Bulletin No. 06-006
Issue/Revision: 01
Prepared By: Julian Rickards
Approved By: Gary Male

Subject: Board Change Notice For SIPS2 Transceivers

Appearance of the product (Below):

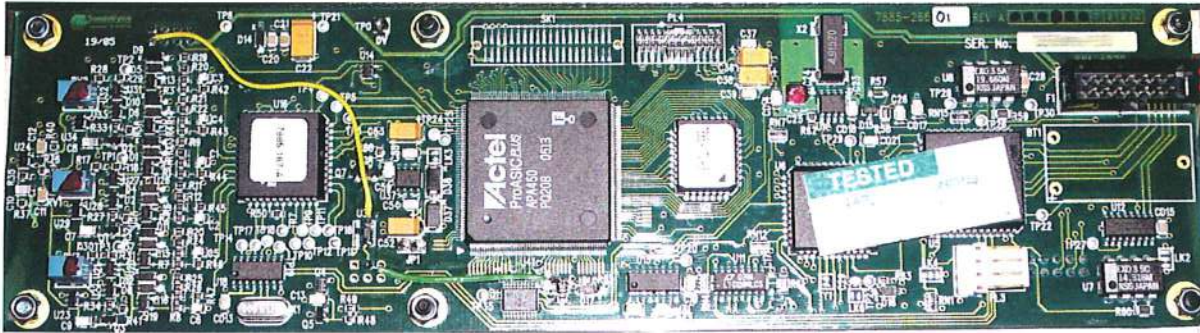
The problem is caused by certain issues of CPU board in SIPS2 transceiver. Affected boards drive the acoustic transceiver in a manner that may shorten the operational life of the Transmit board.

If left unchanged this issue has the potential to over-stress the Tx PCB, which could potentially lead to premature failure.

SIPS 2 transceivers containing: 631-7461 – SIPS FPGA CPU PCB ASSEMBLY 7885-266 (Issue <A7)

The board can be identified by the markings at the top right, affected boards have the following marking:

The potential failure mode is now well understood, we therefore have developed a comprehensive solution which involves a minor modification to the CPU PCB: this rework can be completed in the field by semi-skilled engineers, however to ensure a controlled methodology is employed we recommend that each unit is returned to our offices in Blackbushe, UK. We will contact each customer to ascertain the most suitable method of rectification according to customer circumstances.

The problem does not exist with the newer 7885-266-B CPU PCB or the earlier CPU PCB's 7885-166 or 7885-066.
